# HISTORIC AND DESIGN REVIEW COMMISSION

**HDRC CASE NO:** 2021-321  
**ADDRESS:** 920 BURLESON ST  
**LEGAL DESCRIPTION:** NCB 1369 BLK 6 LOT N 116.5 FT OF 6  
**ZONING:** R-4, H  
**CITY COUNCIL DIST.:** 2  
**DISTRICT:** Dignowity Hill Historic District  
**APPLICANT:** Patrick Callahan/Some Elbow Room  
**OWNER:** TODD ANDREW & NYGAARD LAURA  
**TYPE OF WORK:** Construction of a rear accessory structure  
**APPLICATION RECEIVED:** May 25, 2021  
**60-DAY REVIEW:** Not applicable due to City Council Emergency Orders  
**CASE MANAGER:** Edward Hall

## REQUEST:

The applicant is requesting a Certificate of Appropriateness for approval to construct a rear accessory structure at 920 Burleson, located within the Dignowity Hill Historic District.

12'x20' Front Elevation  
Accessory Structure

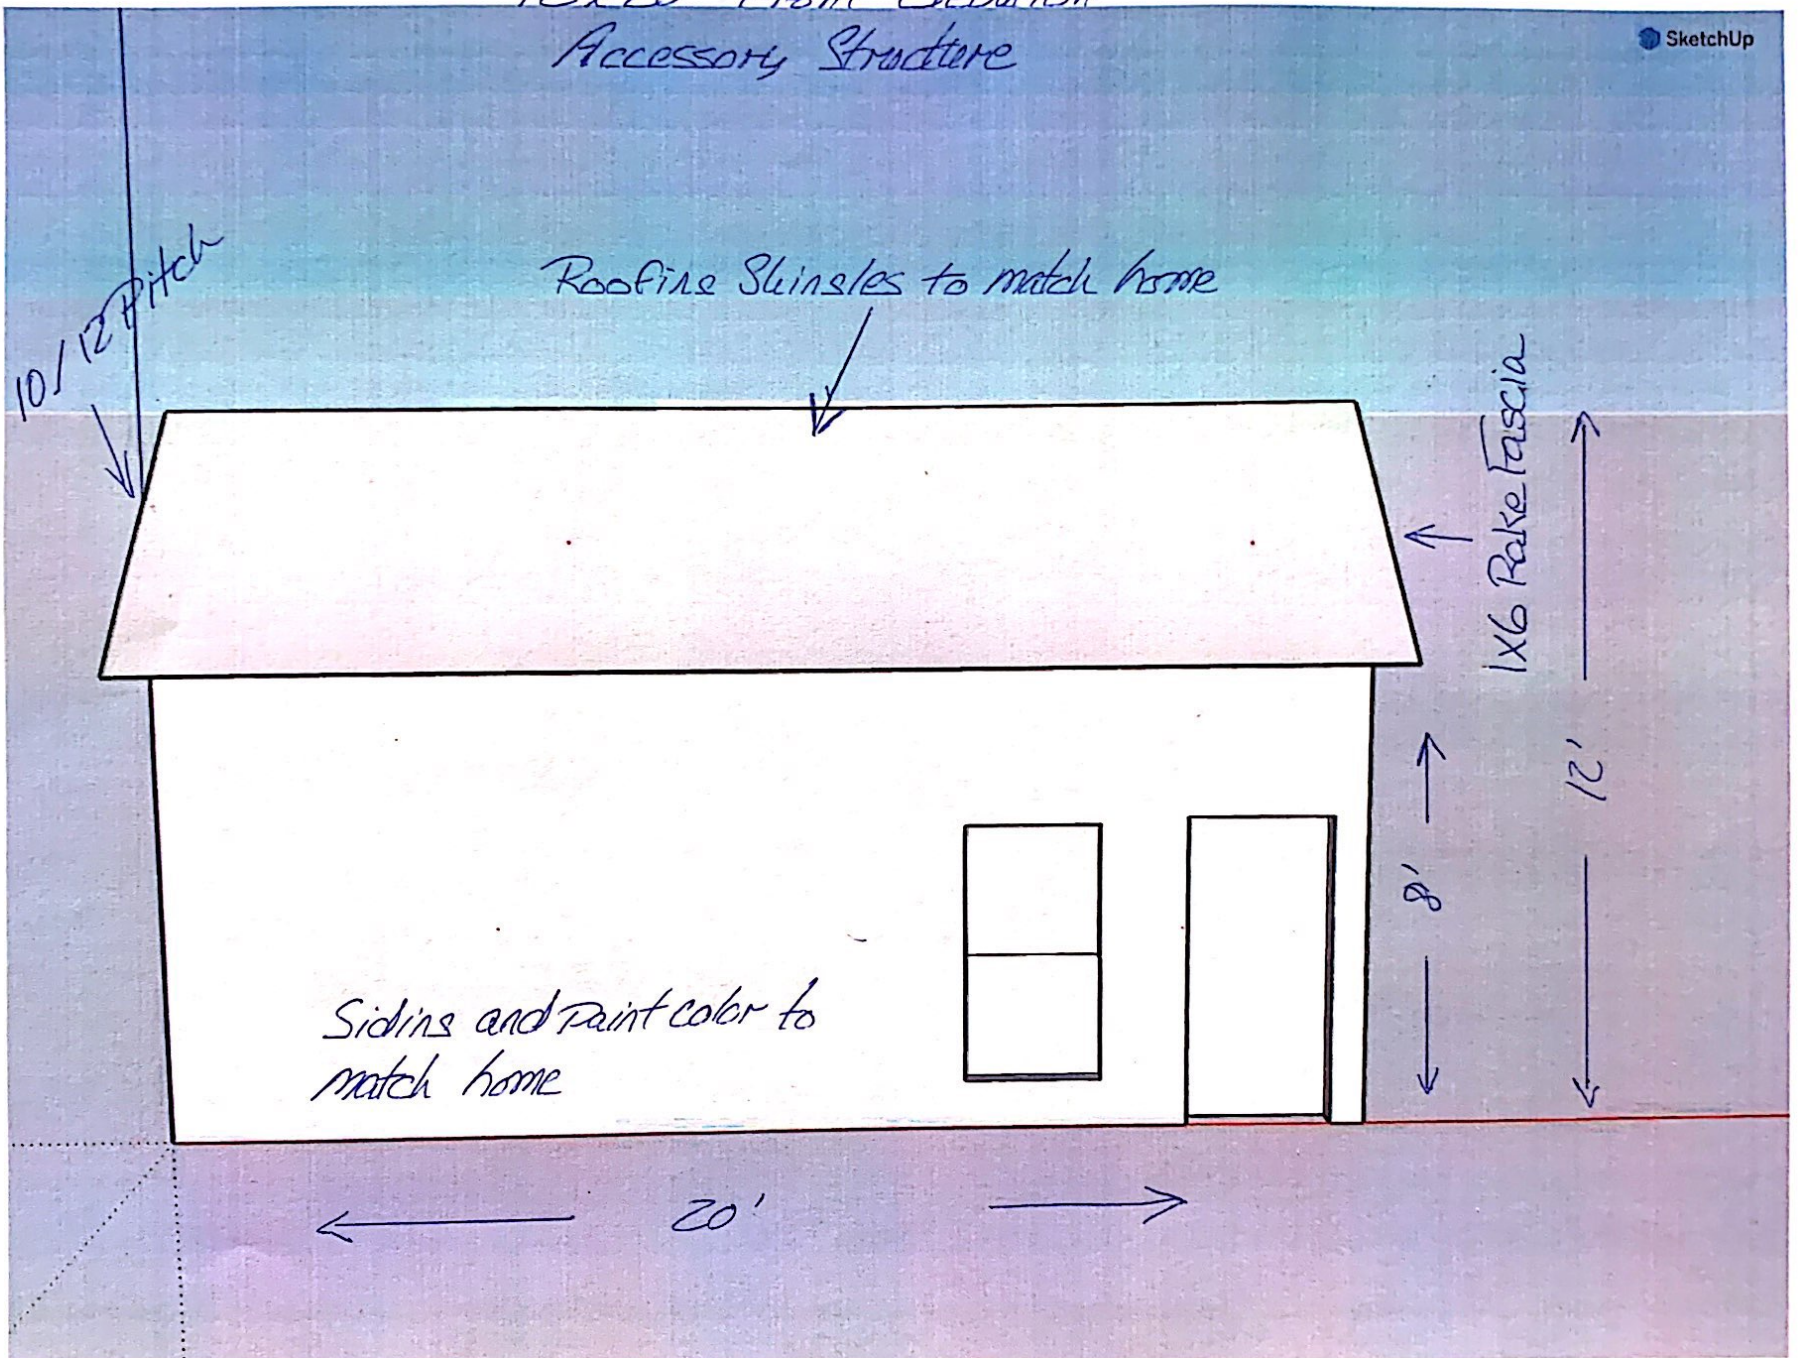
- b. **REAR ACCESSORY STRUCTURE (General Design)** – The applicant has proposed to construct a rear accessory structure to feature a footprint of 240 square feet, siding to match that of the primary historic structure's, and a shingle roof to match that of the primary historic structure's. Per the Guidelines for New Construction 5.A., new accessory structures should be visually subordinate to the primary historic structure on the lot, should be no larger in footprint than forty (40) percent of the primary historic structure's footprint, should relate to the period of construction of the primary historic structure, should feature similar window and door openings as those found historically on the primary historic structure. Generally, staff finds that the proposed rear accessory structure is consistent with the Guidelines for New Construction.

- c. **REAR ACCESSORY STRUCTURE (Windows & Doors)** – The applicant has noted the installation of one door and three windows. At this time, the applicant has not specified window or door materials. Staff finds that windows and doors should be consistent with the Guidelines for New Construction and staff's standard specifications for windows in new construction. These specifications are found in the applicable citations.

- i. That profile 117 siding be installed, matching that of the primary historic structure.
- ii. That the proposed new construction feature windows that are consistent with staff's standard specifications for windows in new construction, as noted in finding c and in the applicable citations.
- iii. That a wood door be installed as noted in finding c.
- iv. That the applicant adhere to all zoning setbacks, as noted in finding d.
